London Road/Abbey Road Improvements – RSA Stage 1 Designer Responses

For Coventry City Council

LAR-JUN-HWY-RSA1-DOC-SM-0001-Rev-01

STAGE 1 & 2 ROAD SAFETY AUDIT
LONDON ROAD SIGNALISED JUNCTION

2.1 Problem

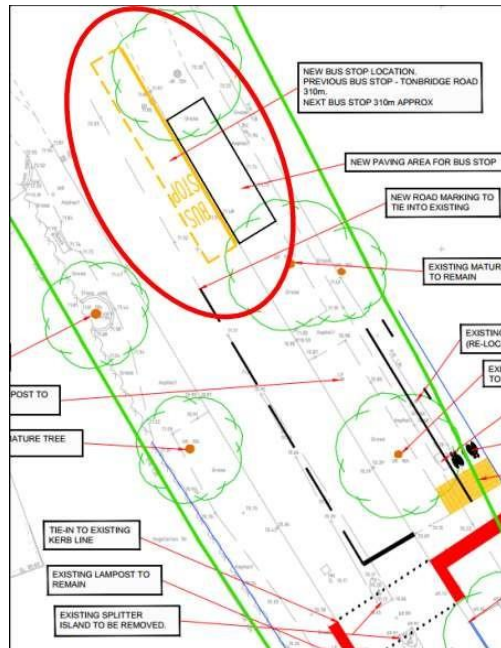
The bus stop relocation is on the approach to the proposed signalised junction, and in particular the signal heads. Buses waiting within the bus stop will significantly reduce the conspicuity of the signal heads (for vehicles on the approach from north-west to south-east) and this significantly increases the risk of vehicle to vehicle and vehicle to pedestrian type personal injury collisions.

Relocate the bus stop to a safer position. This will significantly reduce the likelihood of vehicle-to-vehicle and vehicle to pedestrian type collisions.

The proposed position was discussed on site between Scott Mills and Martin Wilkinson. It was felt that the location indicated provided better visibility of the bus as vehicles approached the junction. London Road is relatively straight as the screen shot below indicates. Alternative locations are possible and were discussed. If the location was moved another 30m north (towards Pinley roundabout, ASDA) then this would clash with the northbound bus stop. This would create an un-desired pinch point for vehicular traffic between the buses. Moving the bus stop much further northbound would make the travel between bus stops greater than the recommended 400m. The distance is currently approx. 330m, so moving further north would increase this to 400m.

It is also noted that the bus stop is located 27.75m from the proposed STOP LINE. At 30mph the braking distance is 23m. It has been tracked back to anticipate a vehicle overtaking the bus and it appears feasible that the signal head could be seen from 37m, as shown below.

2.2 Problem

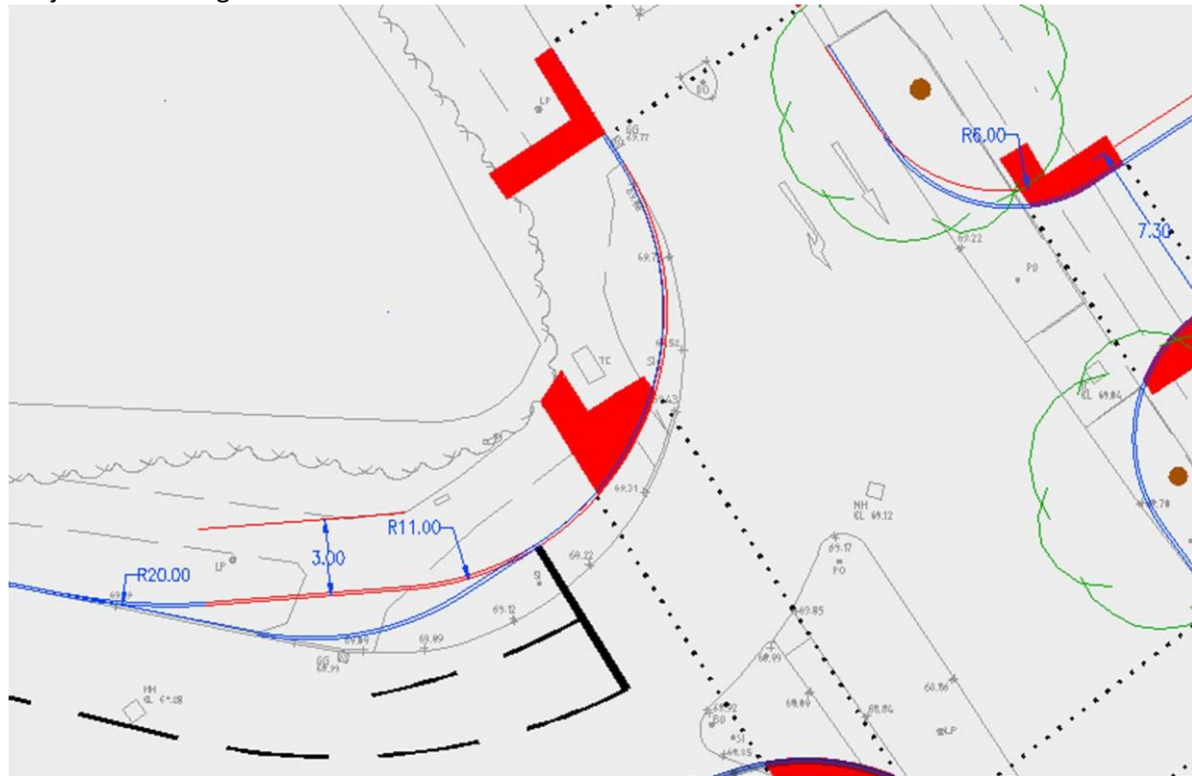
The submitted swept path drawing clearly demonstrates road safety problems related to vehicles turning from London Road into Abbey Road and the new proposed access road. As highlighted in the screen-print below, larger vehicles making the left turn manoeuvre from London Road traverse the central carriageway markings and this significantly increases the likelihood of vehicle to vehicle type personal injury collisions.

Make changes to the design so that larger vehicles can make the left-turn manoeuvre from London Road into Abbey Road and the new access road without traversing the central carriageway markings. This will significantly reduce the likelihood of vehicle to vehicle collisions

This comment is being addressed as part of the continuing design. Comments can be incorporated by increasing roads widths and adjusting kerb lines generally as indicated below, subject to tracking revision.

2.4 Problem

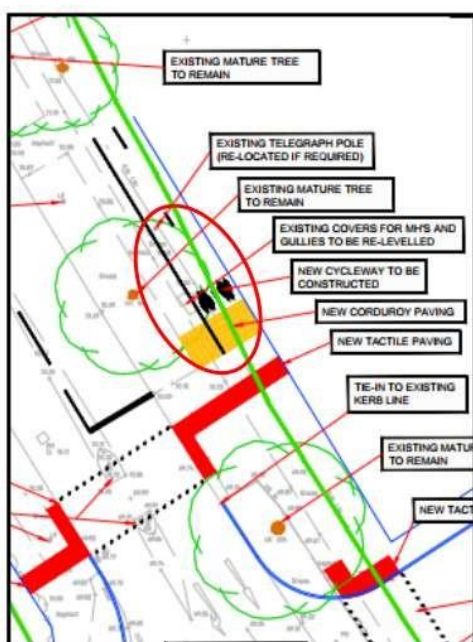
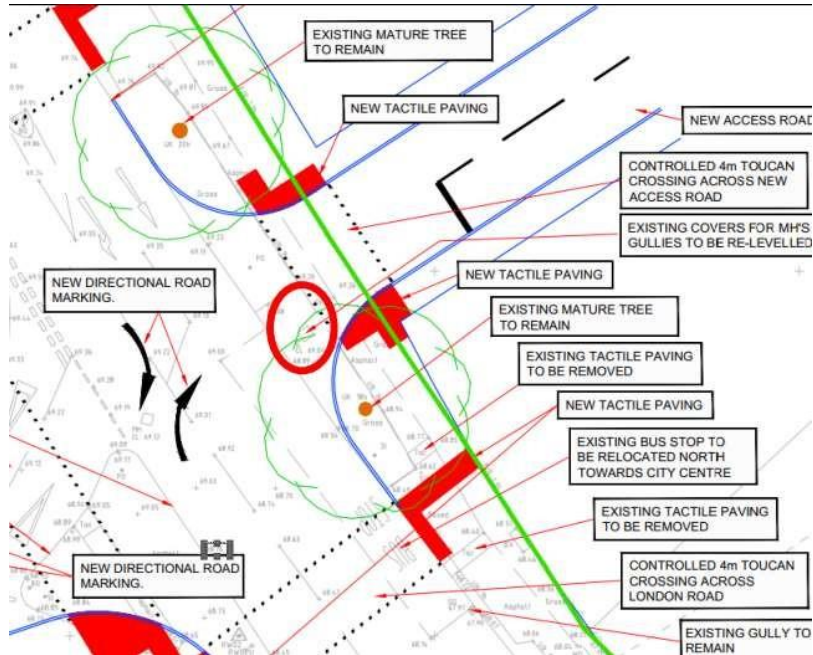
The proposed cycleway on the north-eastern side of London Road is unorthodox as the cyclists will be situated on the inside and pedestrians in the middle adjacent to the road. Cycleways are normally installed adjacent to the highway as they travel faster than pedestrians, and its good practice to keep pedestrians away from higher modes of transport. In addition, cyclists adjacent to the highway are not close to the verge/ trees or street furniture. Installing a cycleway at the back of the footway and pedestrians in the middle of the footway significantly increases the likelihood of cycle to pedestrian type personal injury collisions. The relocation of the footway adjacent to the carriageway also results in pinch points for wheelchair and mobility scooter users due to existing trees, which may result in them having to use the cycle track, which will increase the likelihood of cycle to pedestrian type personal injury collisions.

1. Re-examine the cycleway design on the north-eastern side of the scheme
2. Ensure the proposed cycleway infrastructure is connected to the existing

This comment is being addressed as part of the continuing design. The north-eastern cycleway will be switched with the footway so it is closer to the main highway.

The remaining cycleway network comprises a segregated network linking towards Toll Bar End. There is also a cycleway linkage up Abbey Road and Ashington Road (including a crossing). There are currently no cycleway links on the northern footway of London Road, so this will need to be improved if possible.

2.1 Problem: Bus stop Location

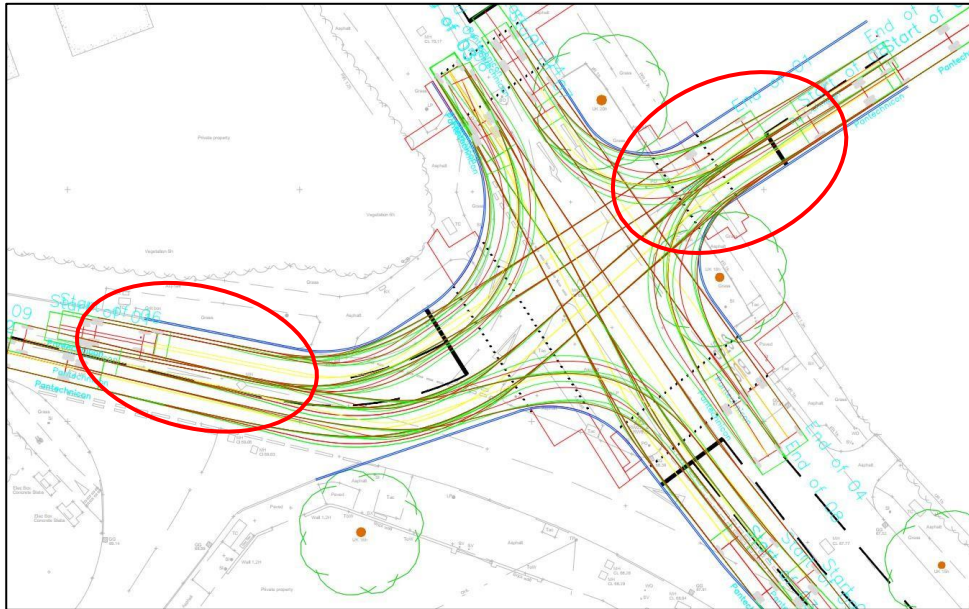
The bus stop relocation is on the approach to the proposed signalised junction, and in particular the signal heads. Buses waiting within the bus stop will significantly reduce the conspicuity of the signal heads (for vehicles on the approach from north-west to south-east) and this significantly increases the risk of vehicle to vehicle and vehicle to pedestrian type personal injury collisions.

Relocate the bus stop to a safer position. This will significantly reduce the likelihood of vehicle-to-vehicle and vehicle to pedestrian type collisions.

2.2 Problem: Swept Path analysis

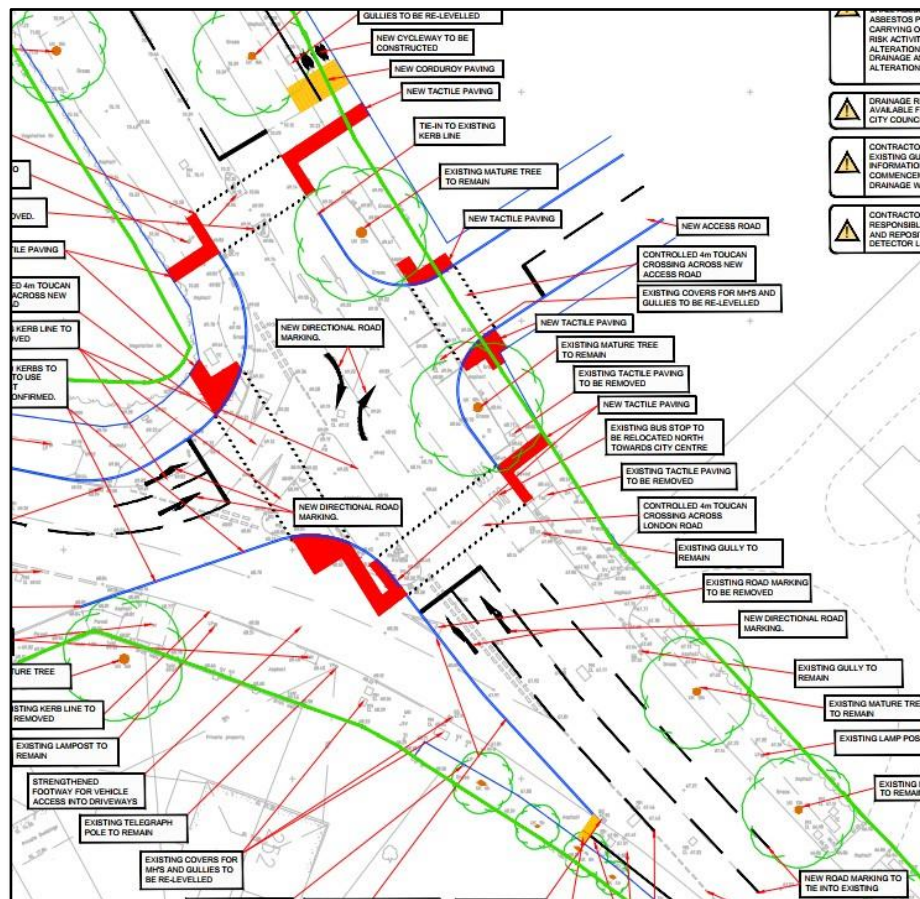
The submitted swept path drawing clearly demonstrates road safety problems related to vehicles turning from London Road into Abbey Road and the new proposed access road. As highlighted in the screen-print above, larger vehicles making the left turn manoeuvre from London Road traverse the central carriageway markings and this significantly increases the likelihood of vehicle to vehicle personal injury collisions.

Make changes to the design so that larger vehicles can make the left-turn manoeuvre from London Road into Abbey Road and the new access road without traversing the central carriageway markings. This will significantly reduce the likelihood of vehicle to vehicle collisions.

Problem: General carriageway markings

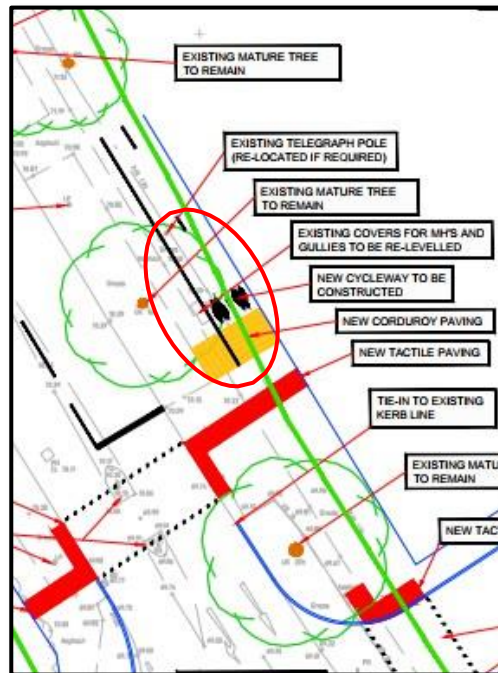
The proposed highway lining and signage is inadequate and this compromises safety throughout the scheme. The drawing highlights incorrect carriageway markings such as diag 1004 whereby they should be to diag 1005; this may result in driver confusion. In addition, there are no proposed advanced direction arrows on any of the approaches, and subsequently this may result in late driver decision making and this may result in personal injury collisions related to side-swipes.

The approach to Abbey Road (drivers travelling from south-east to north-west) is confusing for drivers as there is no guidance. The lack of lining, such as bifurcation markings, significantly increases the likelihood of vehicle-to-vehicle personal injury collisions.

1. Evaluate the proposed lining and signing to ensure it is adequate and satisfies the requirements set out in TSRGD.
2. Install "wicket" signs to compliment the carriageway markings

2.4 Problem: Various cycleway facilities

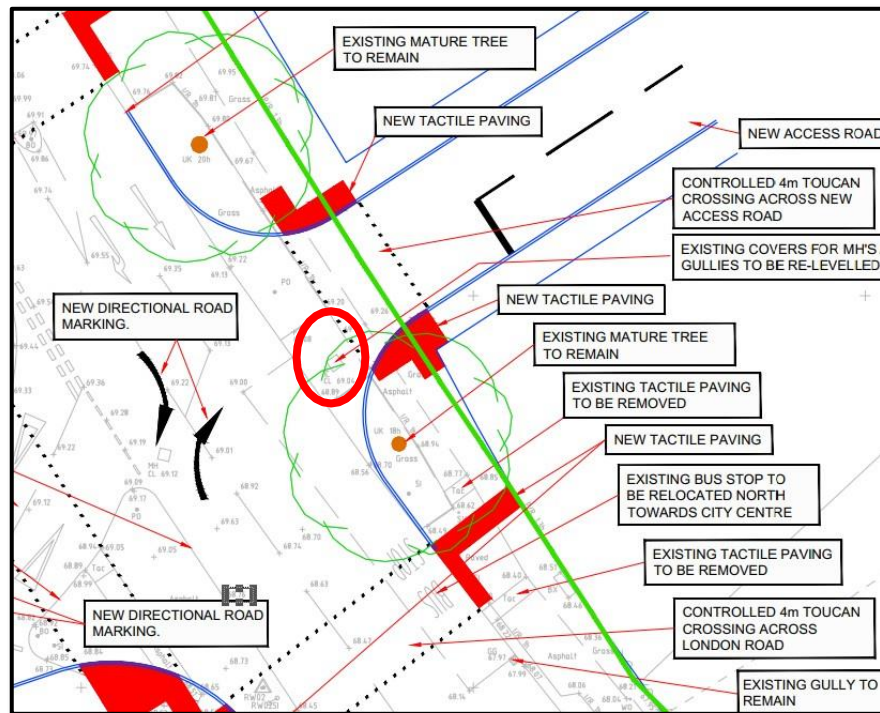
The proposed cycleway on the north-eastern side of London Road is unorthodox as the cyclists will be situated on the inside and pedestrians in the middle adjacent to the road. Cycleways are normally installed adjacent to the highway as they travel faster than pedestrians, and its good practice to keep pedestrians away from higher modes of transport. In addition, cyclists adjacent to the highway are not close to the verge/ trees or street furniture. Installing a cycleway at the back of the footway and pedestrians in the middle of the footway significantly increases the likelihood of cycle to pedestrian type personal injury collisions. The relocation of the footway adjacent to the carriageway also results in pinch points for wheelchair and mobility scooter users due to existing trees, which may result in them having to use the cycle track, which will increase the likelihood of cycle to pedestrian type personal injury collisions

1. *Re-examine the cycleway design on the north-eastern side of the scheme*
2. *Ensure the proposed cycleway infrastructure is connected to the existing*
